SEWAGE DISPOSAL TESTING

HOWARD COUNTY HEALTH DEPARTMENT
ENVIRONMENTAL HEALTH SERVICES

Addition to:
 Lot 1, Rea Subdivision
 5105 Sheppard Lane,
 Ellicott City, MD 21042

Percolation Certification Plan

1/25
 R. H. SHEPPARD LANE
 LOT 1

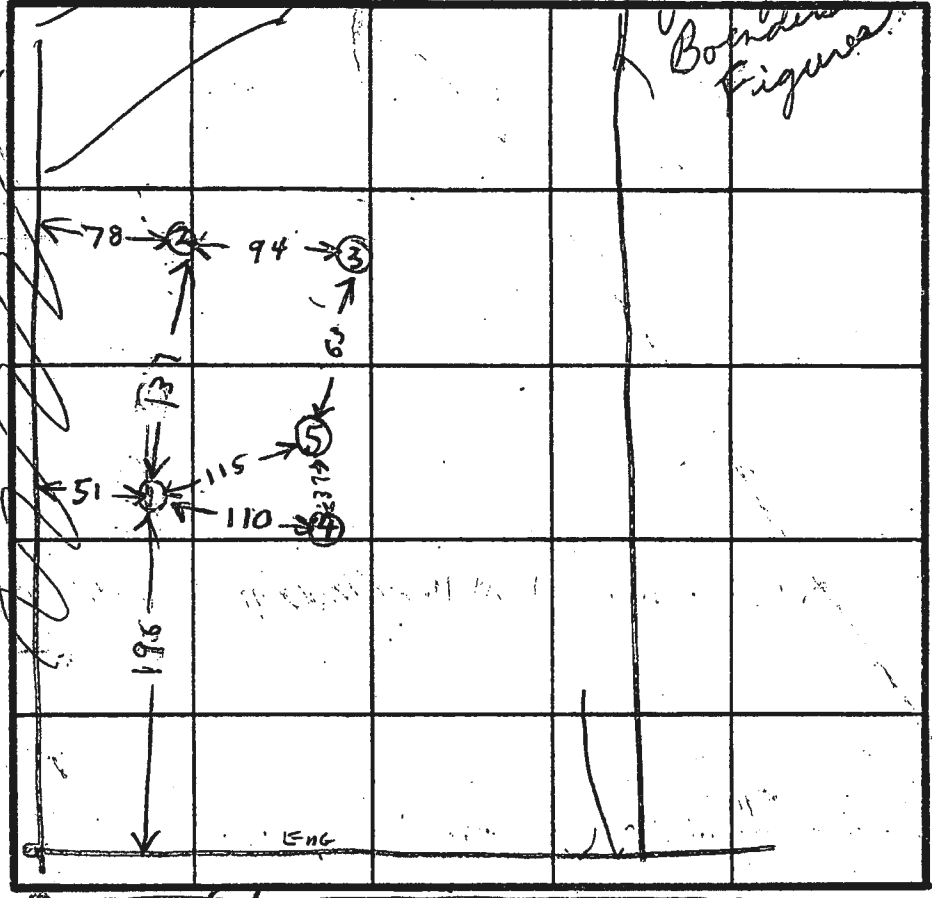
Reviewed OK TO PROCESS
EXISTING house REMOVE. NO NEED TO
ESTABLISH REPAIR AREA AT THIS TIME.
S. Hill

Decided
 This was a
 mistake
 go by
 Boundary
 Figures

REMARKS: HOLES NOT DUG PER PLAN
 (HOLE 1) IS SPOTTY AT 4 FT LEVEL
 TYPE OF SOIL: SAND POCKETS & CLAY POCKETS
 BELOW 5 FT ALL SAND
 TESTED BY: R. HOITGES
 ALSO PRESENT: JACK ROCKY, SKIP
